ADDENDUM NO. 1 - OUTLINE AND SUMMARY INFORMATION

Project Name: Gaines Hall Water Main Replacement Phase 2

PPA No.: 23-0730

Date: 11/12/2024

SHEET TITLE
C1.1
SHEET
EXISTING CONDITIONS
DATE
11/12/2024

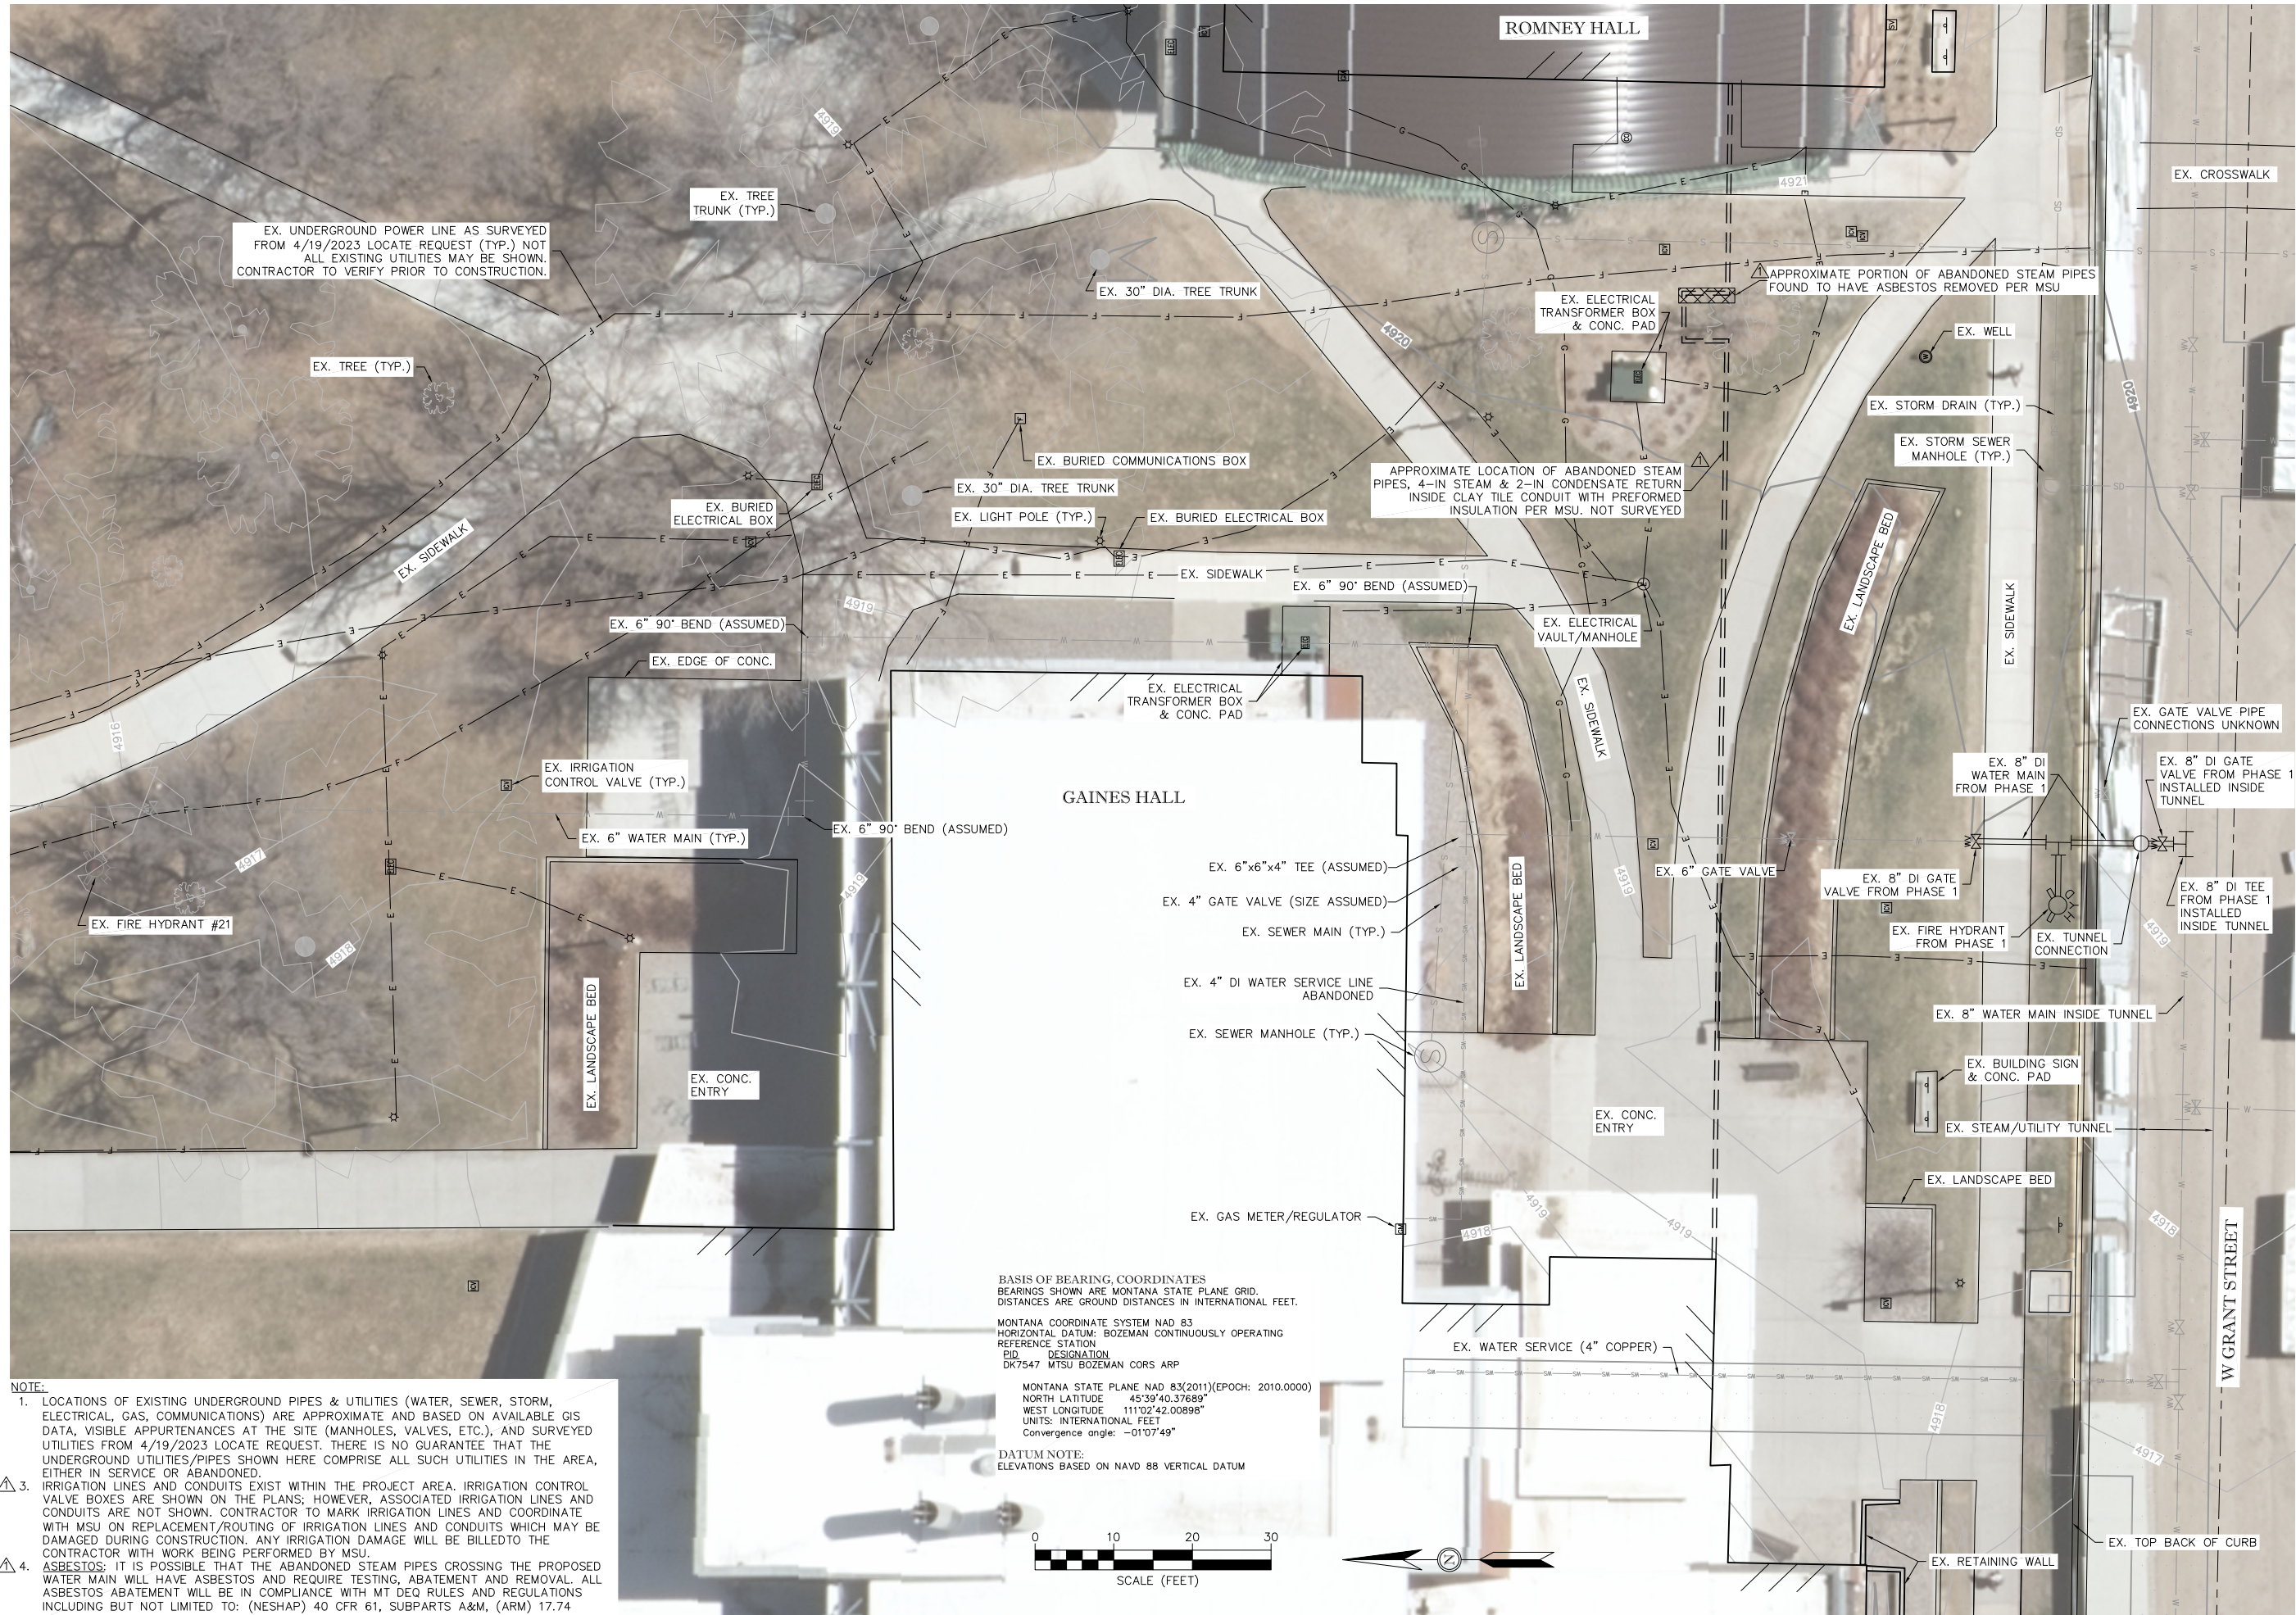
- a. Clarification: Landscaping improvements associated with Grant Street have been made in the project vicinity and are not reflected on Existing Conditions sheets C1.1 and C1.2. Approximate hardscaping improvements per plans for Grant Street improvements project are shown on C1.3 and C2.1. Current rock in the landscape has a mesh sheet underneath which can be easily cut and folded back to ensure minimal disruption to landscaping. Contractor is responsible for restoring landscaping areas to original condition.

- b. Additional Information: Sheet C1.1, C1.2 and C1.3: Note updated: *Irrigation lines and conduits exist within the project area. Irrigation control valve boxes are shown on the plans; however, associated irrigation lines and conduits are not shown. Contractor to mark irrigation lines and coordinate with MSU on replacement/routing of irrigation lines and conduits which may be damaged during construction. Any irrigation damage will be billed to the contractor with work being performed by MSU.*

- IRRIGATION LINES AND CONDUITS EXIST WITHIN THE PROJECT AREA. IRRIGATION CONTROL VALVE BOXES ARE SHOWN ON THE PLANS; HOWEVER, ASSOCIATED IRRIGATION LINES AND CONDUITS ARE NOT SHOWN. CONTRACTOR TO MARK IRRIGATION LINES AND COORDINATE WITH MSU ON REPLACEMENT/ROUTING OF IRRIGATION LINES AND CONDUITS WHICH MAY BE DAMAGED DURING CONSTRUCTION. ANY IRRIGATION DAMAGE WILL BE BILLED TO THE CONTRACTOR WITH WORK BEING PERFORMED BY MSU.

C2.1

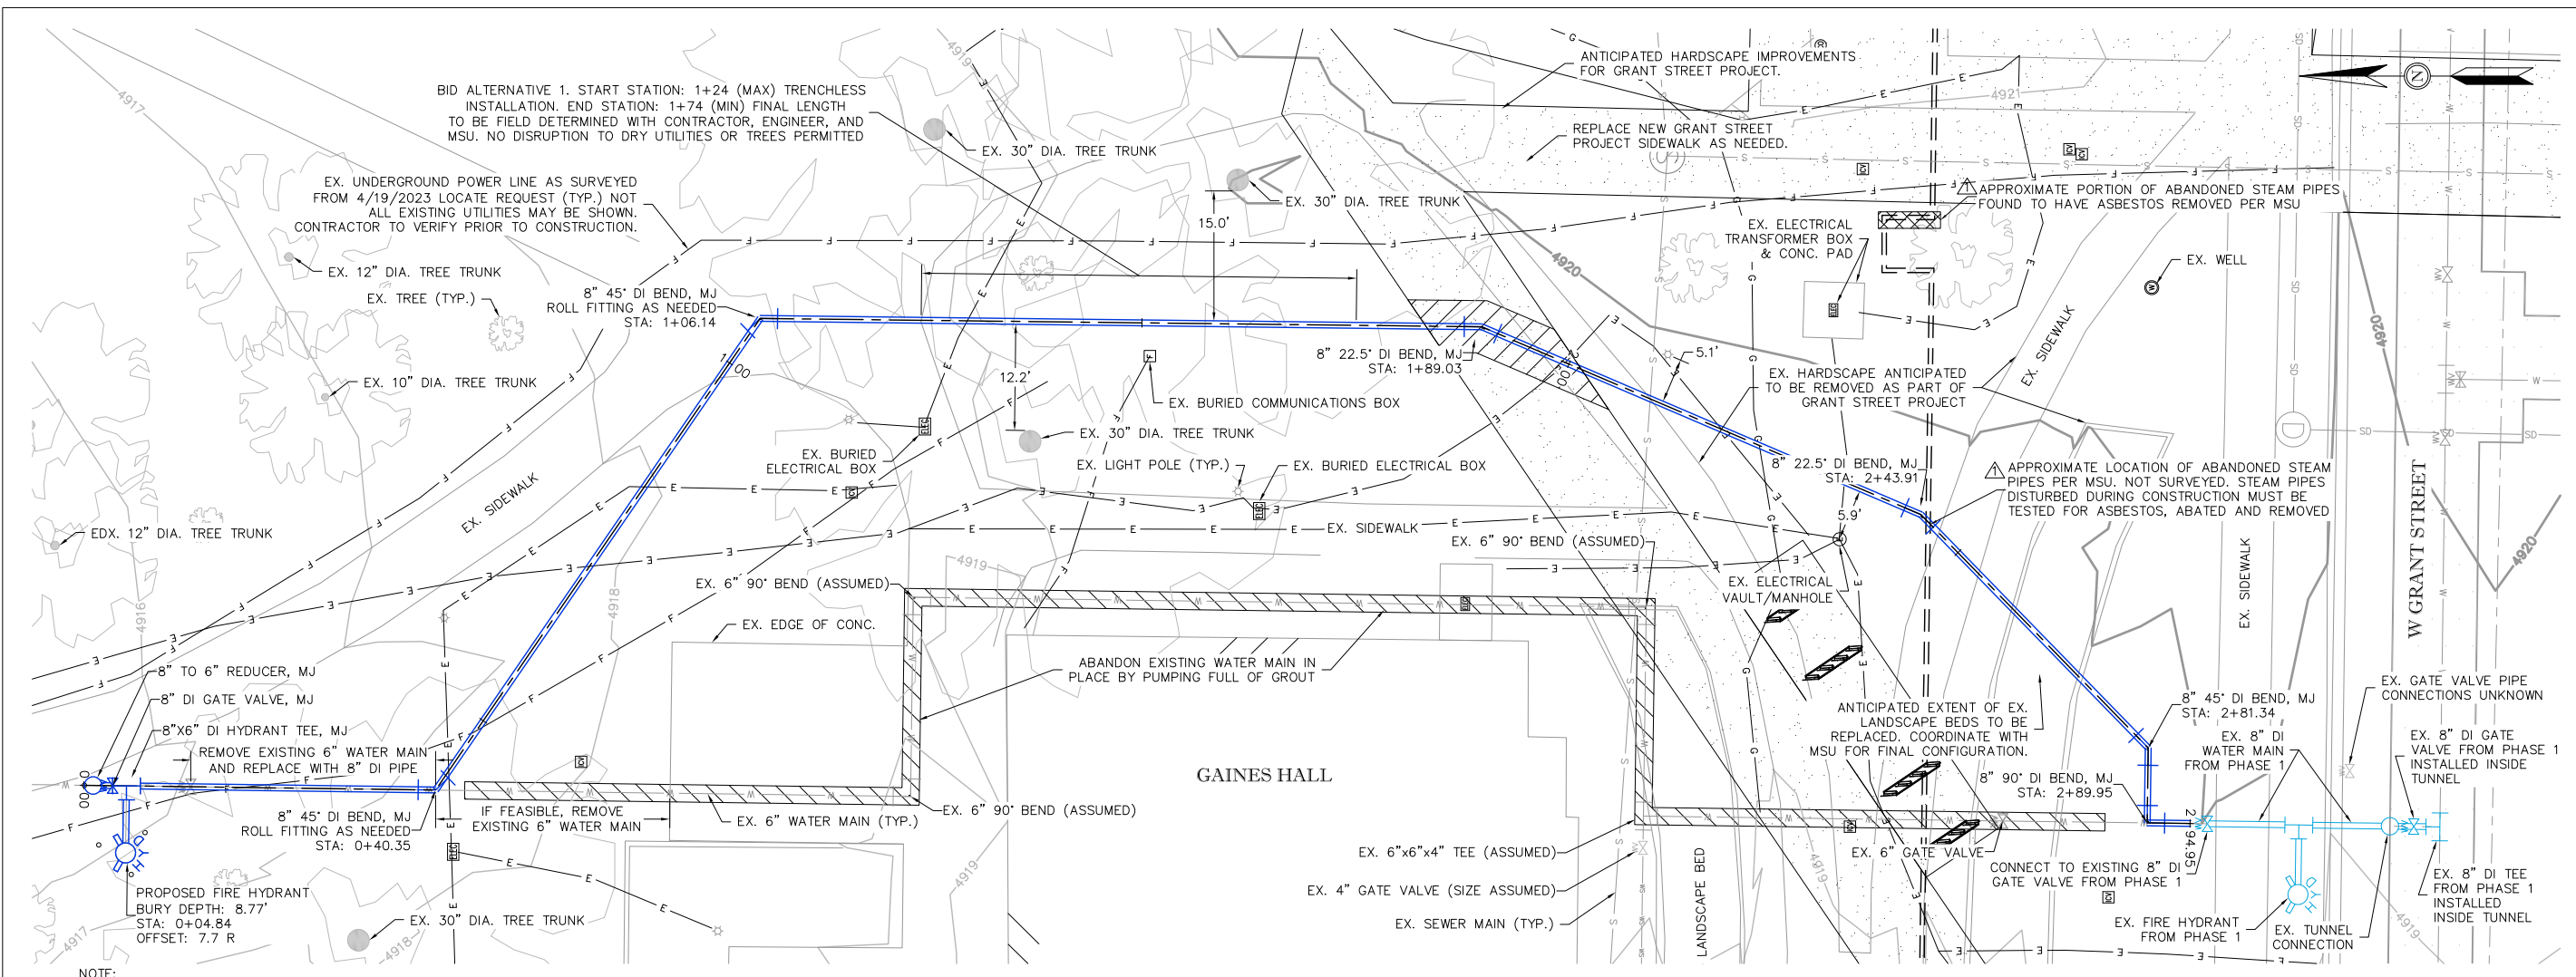
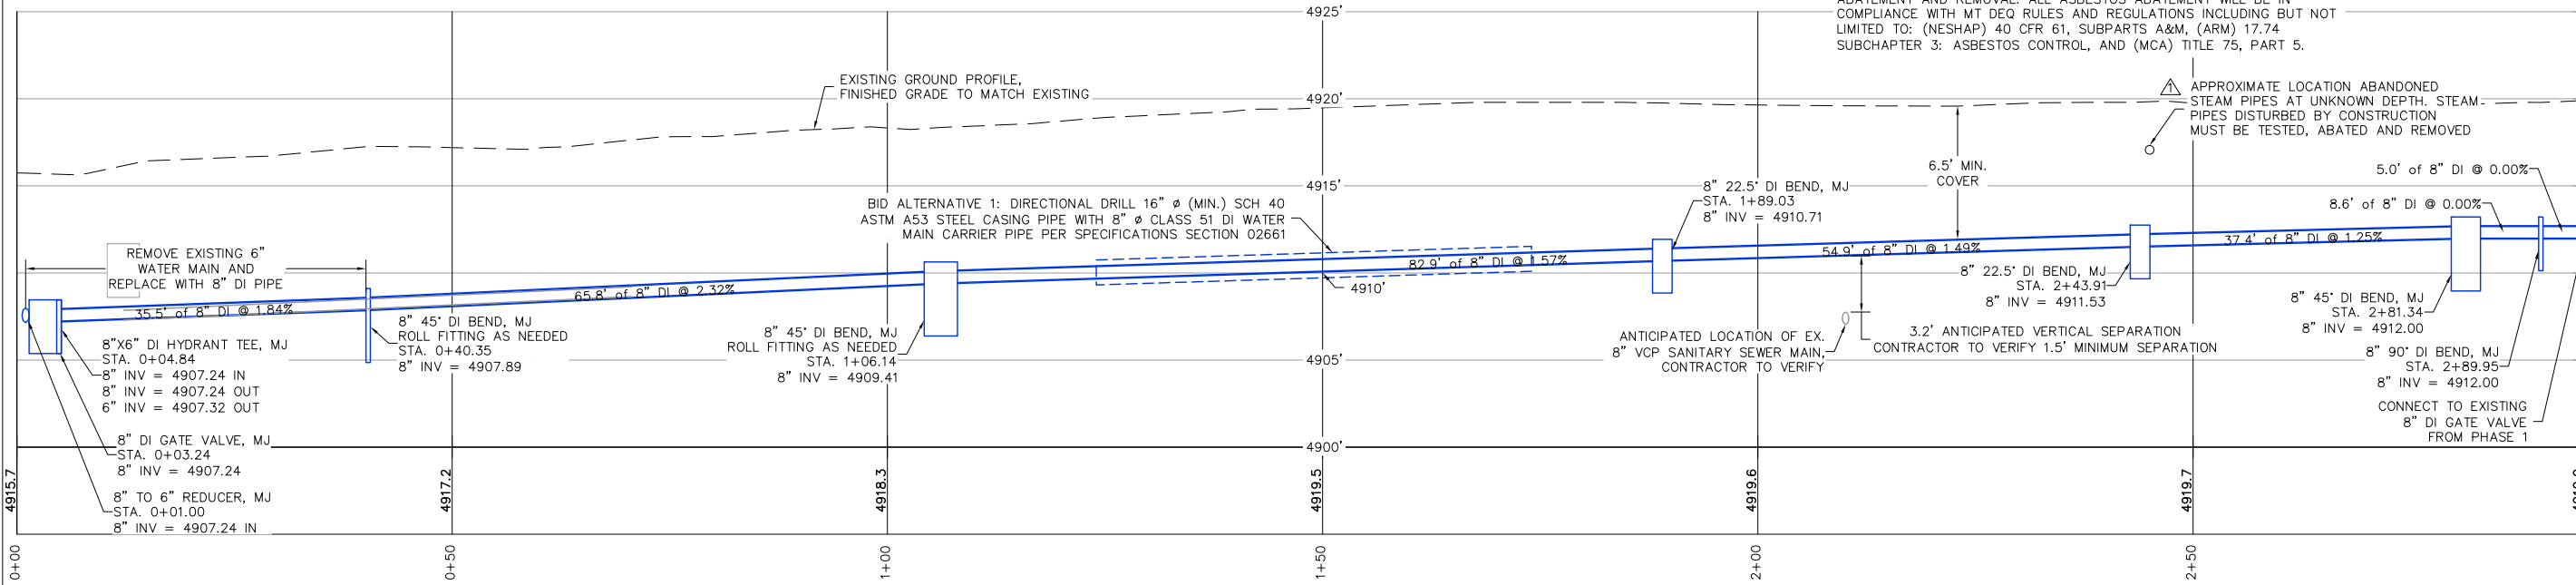
- c. Clarification: Bollards were previously shown around hydrant #21 on C2.1 but not on sheet C1.3. Sheet C1.3 has been updated to reflect the desired bollards. Bollards are required at the new hydrant.

- d. Clarification: Regardless of excavation method through mature trees at approximate station 1+24 to 1+74, contractor shall notify and coordinate with MSU upon exposing tree roots prior to continuing excavation through tree roots.
- e. Additional Information: Sheets C1.3 and C2.1: Scope of Work shall include: An abandoned steam line which crosses the proposed water main was previously found to have asbestos. The contractor shall test, abate and remove the steam pipe if encountered.

APPROXIMATE LOCATION ABANDONED STEAM PIPES AT UNKNOWN DEPTH. STEAM PIPES DISTURBED BY CONSTRUCTION MUST BE TESTED, ABATED AND REMOVED
